**AMBLER BOROUGH COUNCIL
BUSINESS MEETING AGENDA
July 21, 2026, 7:00 p.m.**

PRELIMINARY AND FINAL LAND DEVELOPMENT PLANS FOR AMBLER CROSSINGS - PHASE II

H2 Engineering LLC 409 E. 1st Ave., Unit B Drexelton, PA 19021 www.h2engineering.net	
AMBLER CROSSINGS - PHASE II MAPLE AVENUE AND CHESTNUT AVENUE TWP # 03-00-0157-3D-9 AMBLER BOROUGH, MONTGOMERY COUNTY, PENNSYLVANIA	
AERIAL PLAN

DATE: 2/6/2026
DATE: 12/1/2025
DATE: 7/11/2025
PROJECT # 1845
DRAWING # CO.0
SHEET 1 OF 25

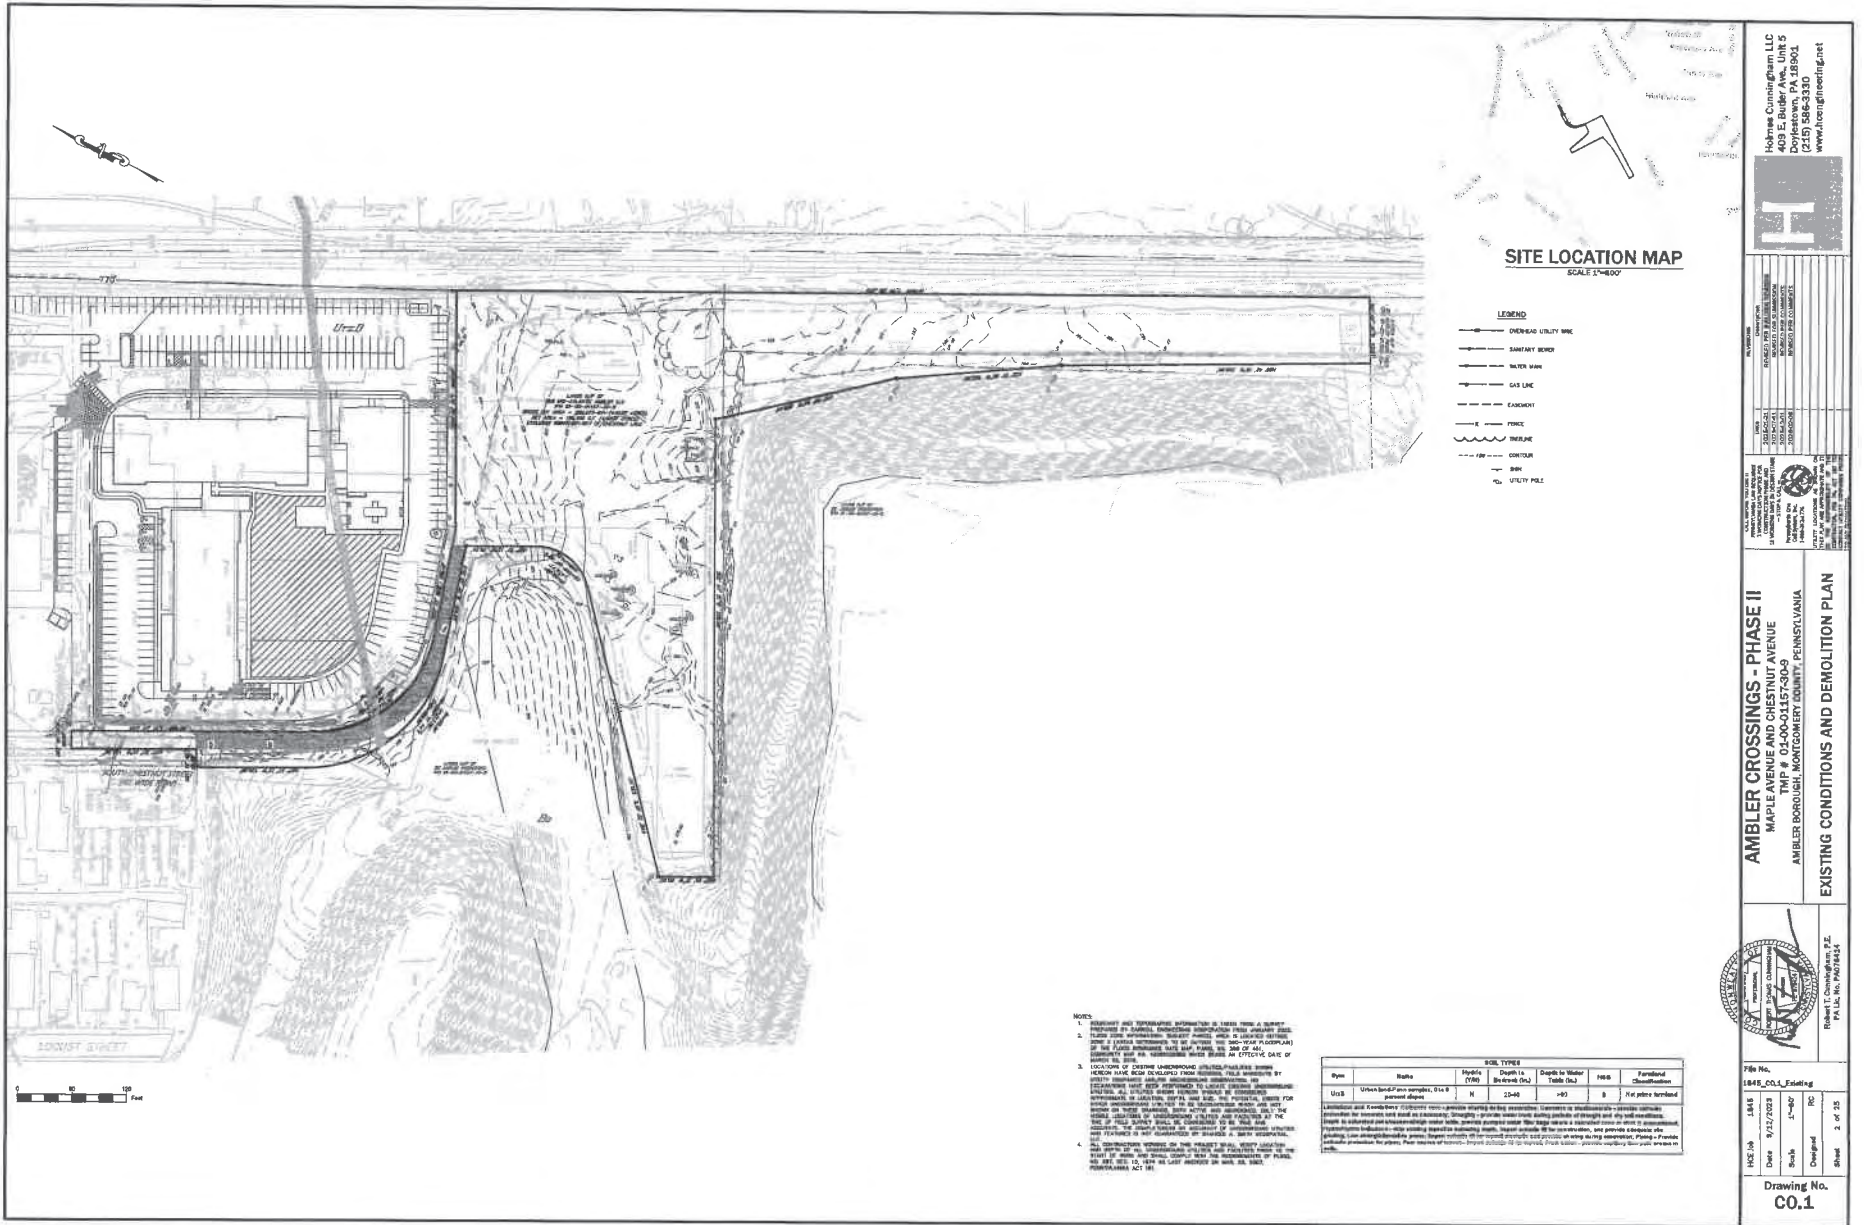
9. §27-2703.E(4)(a)(1) – A TOD use must be located with 800 feet of an active or proposed commuter rail station. The 800-foot requirement shall be measured from the nearest property line of the TOD to the nearest edge of the passenger platform of the commuter rails station. This distance shall be documented on a plan.

13. §22-305.4.A and §22-306.A(2) – The plan shall include existing features within 400 feet of any part of the land being developed.

Response: A Plan Sheet C0.2 has been provided showing the distance to the nearest edge of a passenger platform of the SEPTA Ambler Train Station. Additionally, this requirement has been added to the Zoning Data Table.

Response: A plan sheet C0.2 has been added to the plan with an Aerial photograph to show off-site features.

RECORD SITE PLAN

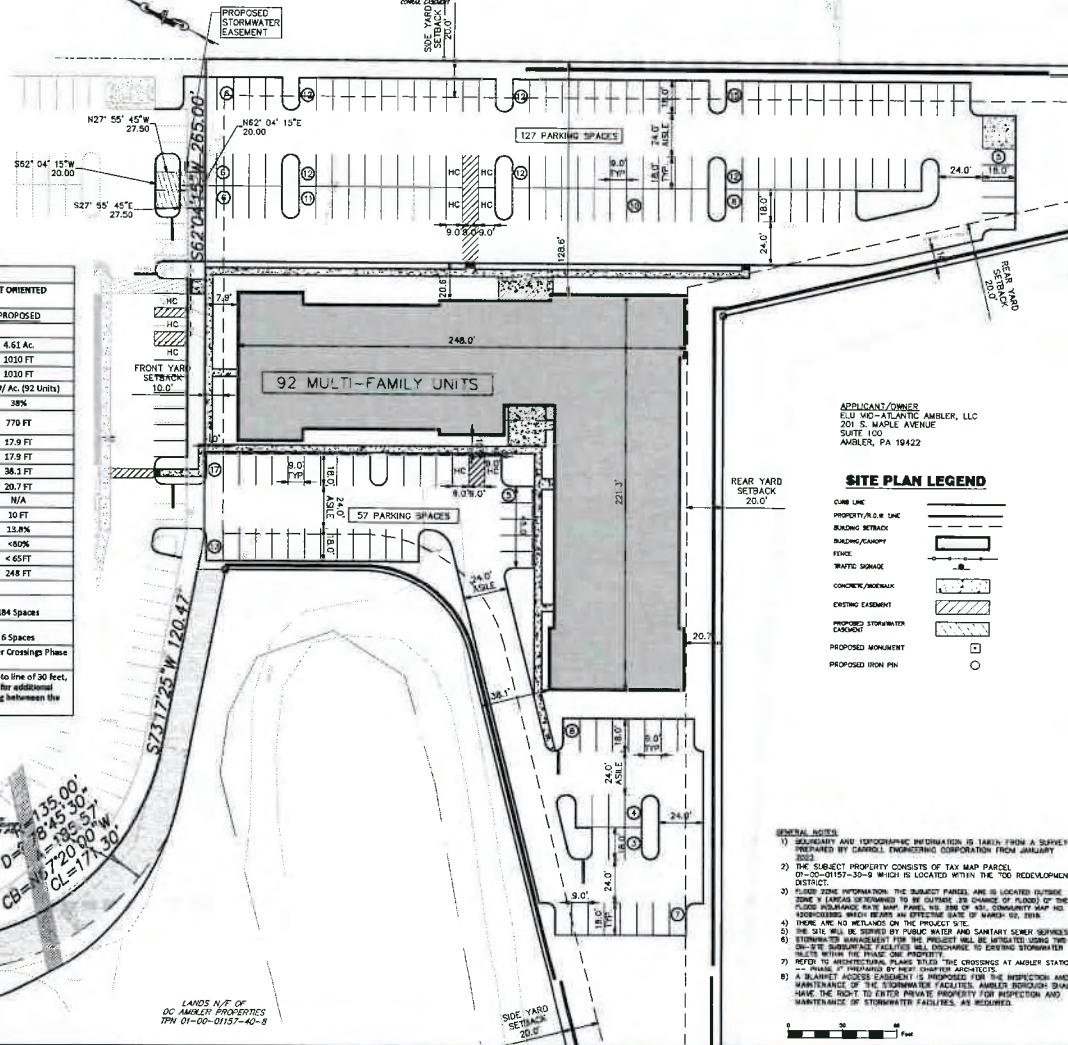
3. §27-2102 and §27-2703.E(4)(e)(3) – Parking spaces are to be removed from the Phase 1 parking area. Verify that adequate parking will continue to be provided in Phase 1. If spaces are shared between Phases 1 and 2, it shall be noted on the plans. It is noted that Phase 1 shares spaces with the Boiler House. The requirements of §27-2703.E(4)(e)(3)(a) and (b), associated with shared parking, shall be addressed.

12. Update the Zoning Data Table on Drawing C1.0 (sheet 3 of 19) to reference the current minimum lot area, minimum lot width, build-to line, etc. Refer to Ordinance No 1140.

32. §26-441.A – The applicant proposes to discharge stormwater to a neighboring property (Crossings Phase I). An easement is required to allow this.

36. General note 6 on Drawing C1.0 should be revised to note the proposed stormwater discharge location.

Response: A Shared Parking Table has been added to Sheet C1.0 to enumerate the spaces shared between the Boiler House, Phase I, and Phase II. A Parking Study has been included with this submission.

Response: On Plan Sheet C1.0, the Zoning Data Table has been revised.

Response: On Plan Sheet C1.0, a stormwater easement is proposed to allow for stormwater to discharge on to the Phase I property.

Response: On Plan Sheet C1.0, general note 6 has been revised.
